**CITY OF SPOKANE PARK BOARD  
RIVERFRONT PARK COMMITTEE**

- The committee passed the following recommendations for the Park Board's approval consideration:
  - Garco Construction change order #23/Pavilion (\$29,714, plus tax)
  - LaRiviere Inc. change order #2/North bank (\$315,565.97, tax inclusive)
  - Bernardo | Wills Architects contract amendment #7/North bank (\$19,430.75, no tax)
- The committee deferred action on the signature art piece recommendation and changed the topic to a discussion item. The group choose not to vote on the Joint Arts Committee's recommendation in order to allow for more public feedback on the proposed pieces before moving forward. Park staff plans to work with Spokane Arts to develop a public outreach and education component to the selection process.
- The April operations report was presented.
- The Riverfront Park redevelopment budget-to-actual update was presented.

**CITY OF SPOKANE  
PARKS AND RECREATION DEPARTMENT  
CHANGE ORDER NO. 02**

PROJECT TITLE: North Bank Playground

RIVERFRONT PARK  
US PAVILION  
RFP EGRESS AND EMERGENCY ACCESS MODS  
B. ELLISON  
MAR 3, 2020  
PAGE 1 OF 1

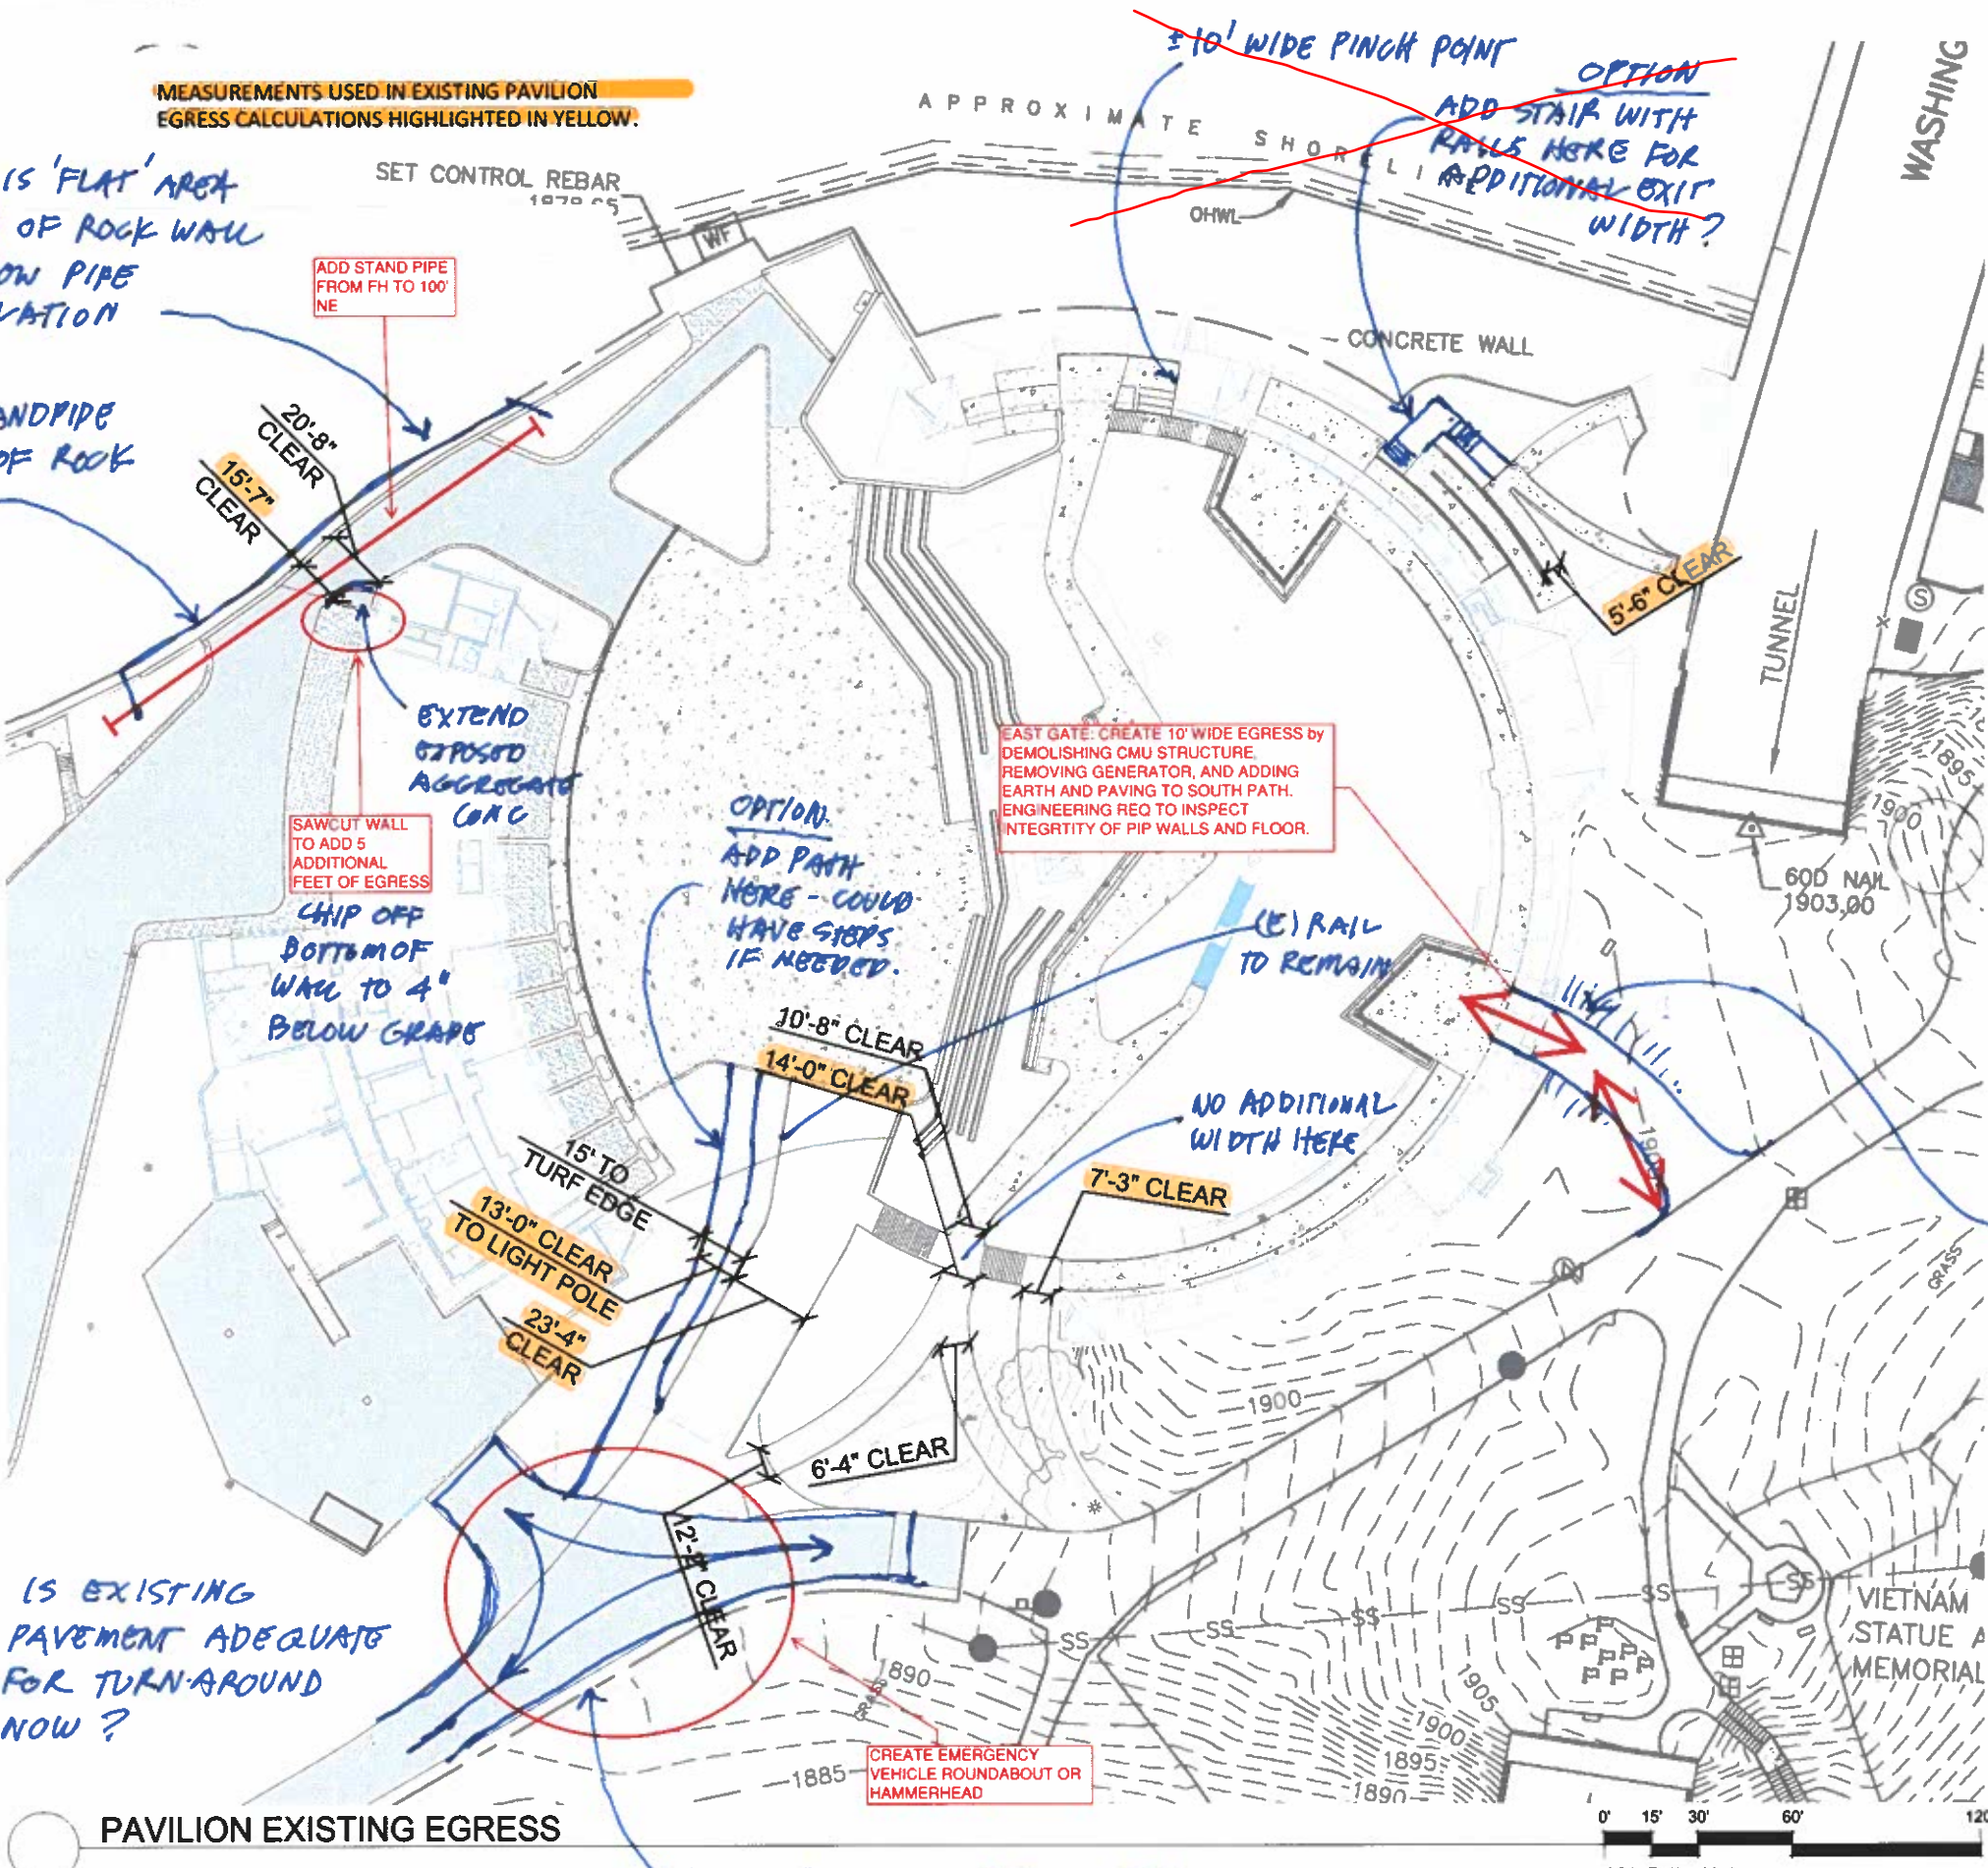
MEASUREMENTS USED IN EXISTING PAVILION EGRESS CALCULATIONS HIGHLIGHTED IN YELLOW.

THERE IS 'FLAT' AREA NORTH OF ROCK WALL TO ALLOW PIPE INSTALLATION

DRY STANDPIPE NORTH OF ROCK WALL

ADD STAND PIPE FROM FH TO 100' NE

SAWCUT WALL TO ADD 5 ADDITIONAL FEET OF EGRESS

CHIP OFF BOTTOM OF WALL TO 4" BELOW GRADE

OPTION: ADD PATH HERE - COULD HAVE STEPS IF NEEDED.

EAST GATE: CREATE 10' WIDE EGRESS BY DEMOLISHING CMU STRUCTURE, REMOVING GENERATOR, AND ADDING EARTH AND PAVING TO SOUTH PATH. ENGINEERING REQ TO INSPECT INTEGRITY OF PIP WALLS AND FLOOR.

NO ADDITIONAL WIDTH HERE

IS EXISTING PAVEMENT ADEQUATE FOR TURN-AROUND NOW?

LIGHT POLES & TREES NEAR EDGE OF ROAD HERE

MAY NEED TO BUILD UP GRADE HERE A FEW FEET - OTHERWISE LOOKS FAIRLY LEVEL - THERE IS FLOOR AT GRADE IN GENERATOR ROOM. PATH TO BE ASPHALT. WHAT IS THRESHOLD CONDITION AT PAVILION PERIMETER?

ADDITIONAL WIDTH  
120" EAST GATE  
60" SAWCUT WALL  
52" DELTA (TO BE DETERMINED)  
232" TOTAL

**1 | SPLASH PAD EQUIP. SCHEMATIC LAYOUT**

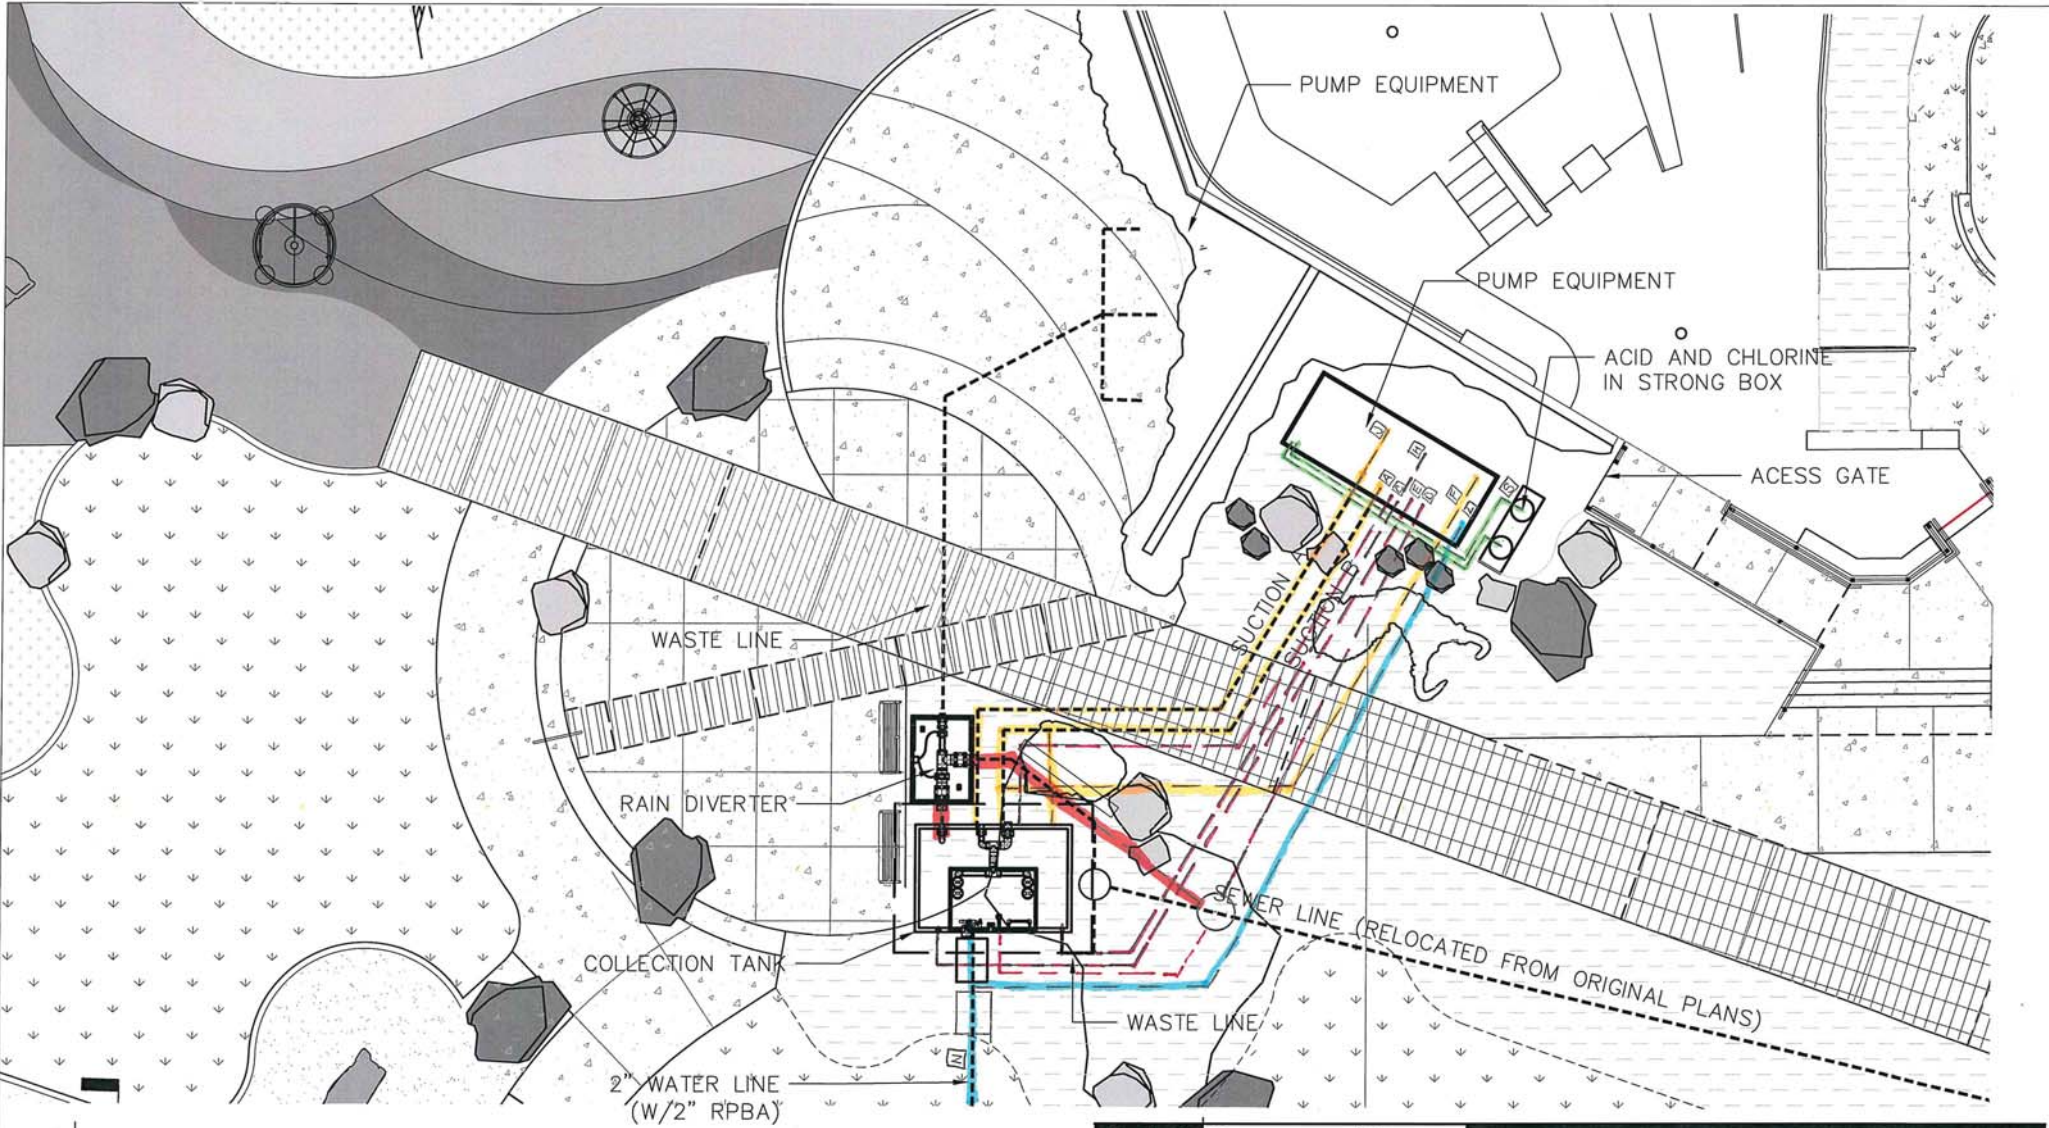
- The estimate includes additional landscaping rock shown on the conceptual CA.1A drawing to screen the equipment enclosure. This covers (5) 24" wide 8'-0 columnar basalt rocks. Due to the underground pipe in this area and the need to burry rocks of this nature an alternate design may be needed.
